AR-06-2684

Southern Nuclear Operating Company
Vogtle Early Site Permit Application
Environmental Site Audit Information Needs

Enclosure: Response to NRC Information Needs from October 2006 Environmental Site Audit for Vogtle ESP Application

AR-06-2684
Enclosure
Attachment A-1 #22

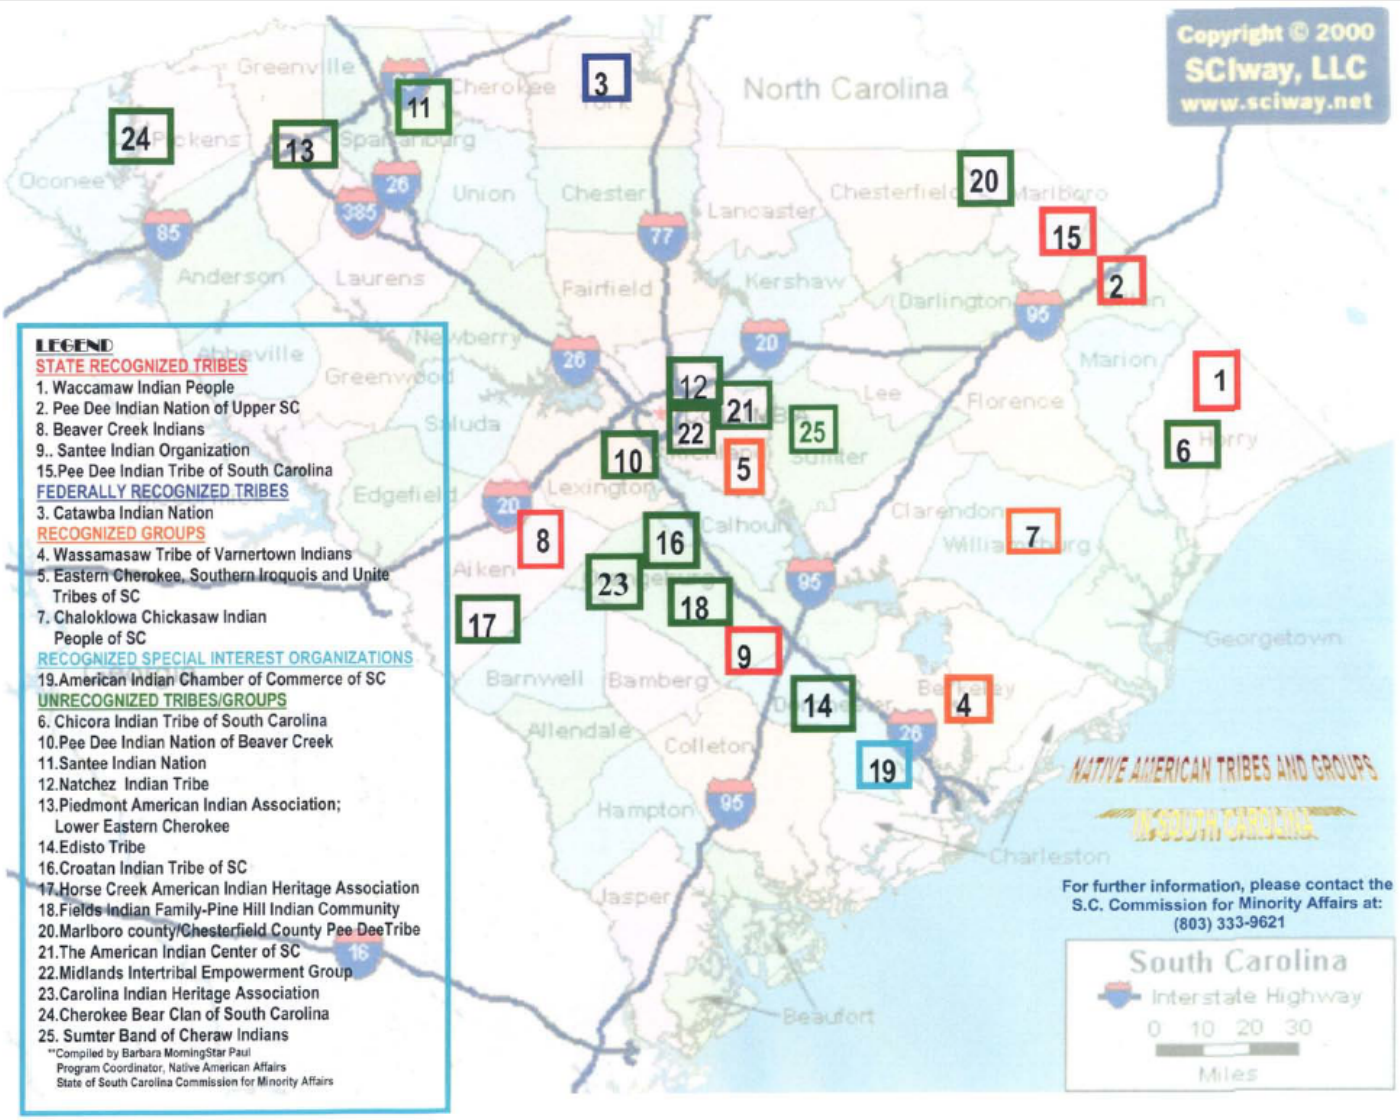
Response: This item was clarified/resolved through audit interaction between SNC and the NRC; No further action is necessary.			
22	The ESP characterization of affected Native American communities on page 2.5-25 does not include South Carolina populations. Provide this analysis.	Socioeconomics and Environmental Justice	Katie Cort

Response: The location and distribution of South Carolina Native American populations are provided in Attachment A-1. <u>This information will be added to the ESP at the next revision.</u>
